# **ADDENDUM NO. 1**

## **2014 - Grove Road Bridge Replacement**

**Essex County, NY**

**June 30, 2014**

## TYPICAL PEDESTRIAN FENCE DETAIL

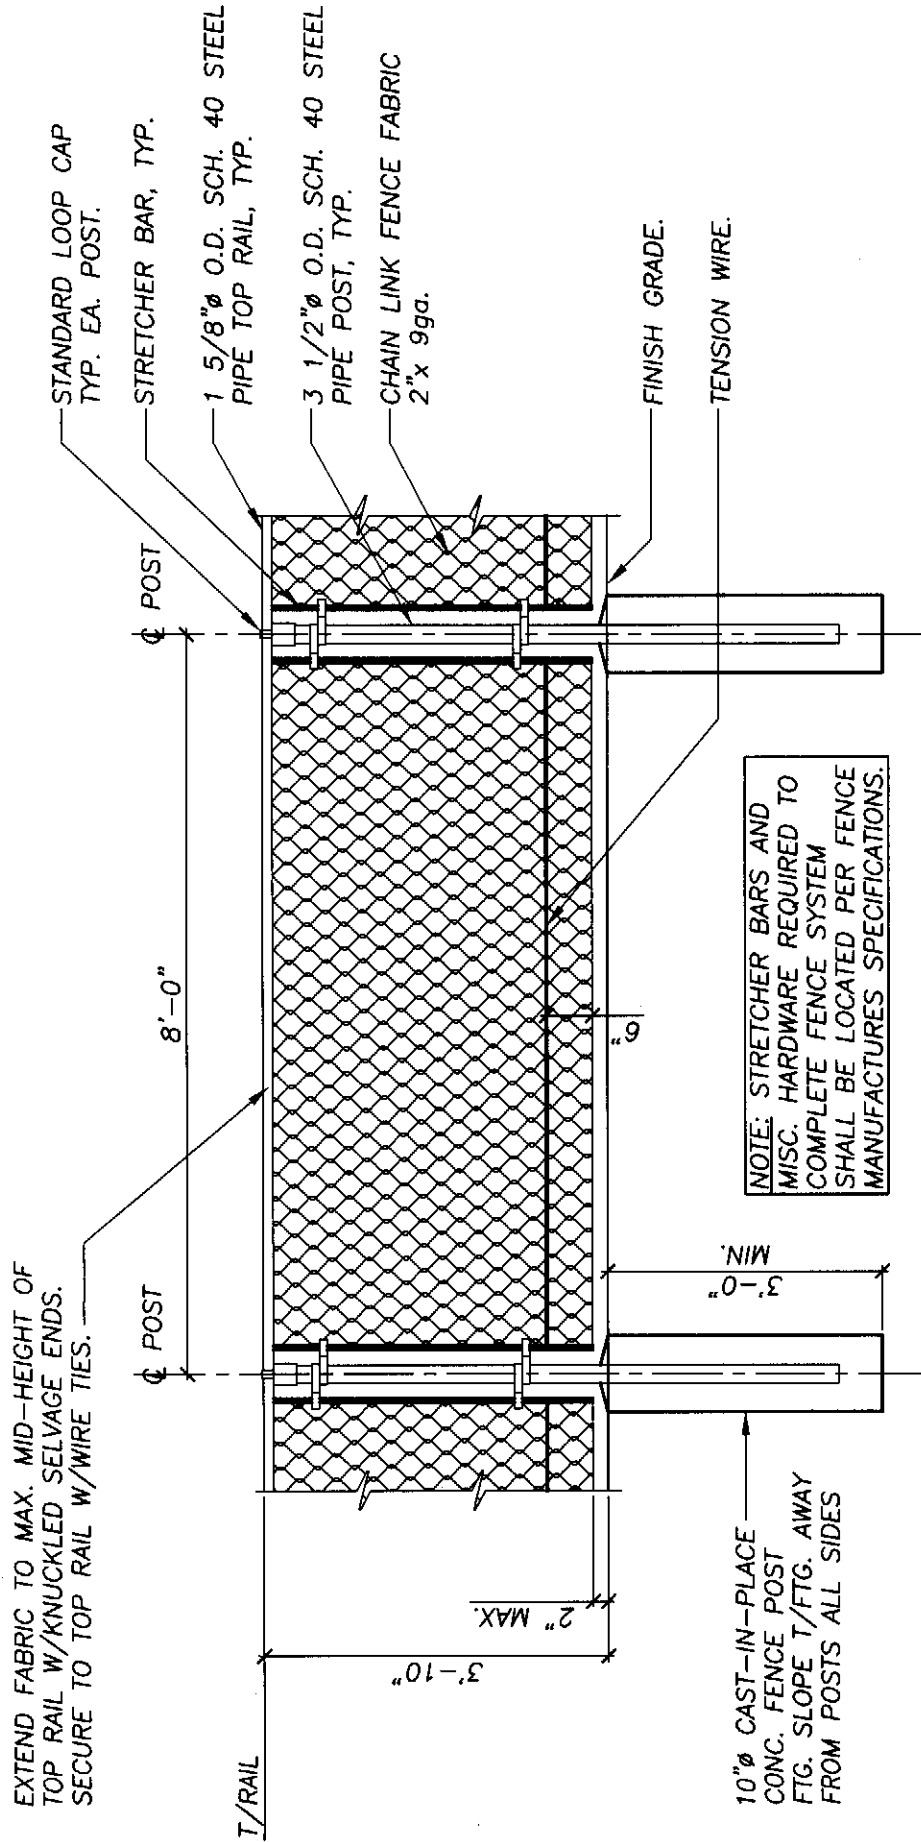
3. **Regarding Drawing C-5: *Typical Pedestrian Fence Detail*** - DELETE the entire detail and SUBSTITUTE THEREFORE the attached *Typical Pedestrian Fence Detail*.
4. **Regarding Drawing N-1: *Pedestrian Fence Notes*** - DELETE all references to fence system bottom rails, boulevard clamps, tension bars and tension bands.
